SERVICE BULLETIN

SERVICE BULLETIN 94-2

SUPER LOOPS (RING OF FIRE)

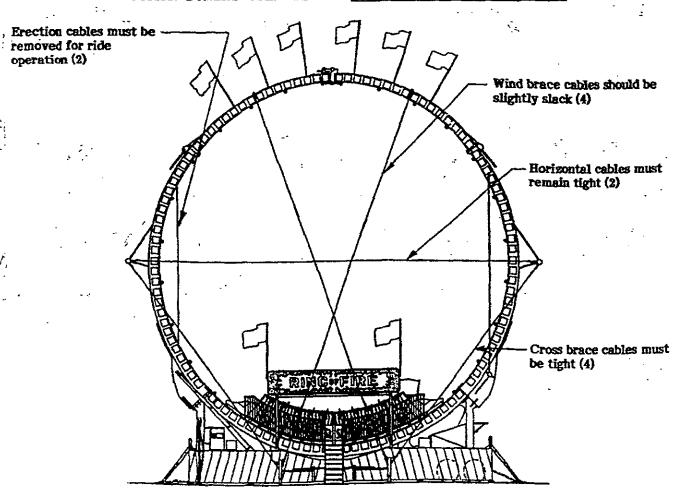
The purpose of this bulletin is to alert ride operators/ride inspectors of the proper cable tensions for Super Loops (Ring of Fire). The illustration below depicts the proper cable tensions on the horizontal and cross brace cables. The two (2) erection cables shown, for illustration ONLY, must be removed before any passengers are allowed on this ride. The reason the erection cables must be removed is so passengers cannot reach hands and arms outside the train and grab the cables.

The reason the wind brace cables must not be tight is to keep the track a true circle. These cables, when overtightened, will crush the circle into an elliptical shape. This causes extreme pressures on the jactuators and the train axles during operation.

THE ERECTION CABLES MUST ABSOLUTELY BE REMOVED FROM RIDE CAUTION: BEFORE PASSENGER OPERATION. DO NOT TIE ERECTION CABLES TO TRACK DURING OPERATION - REMOVE CABLES FROM RIDE!
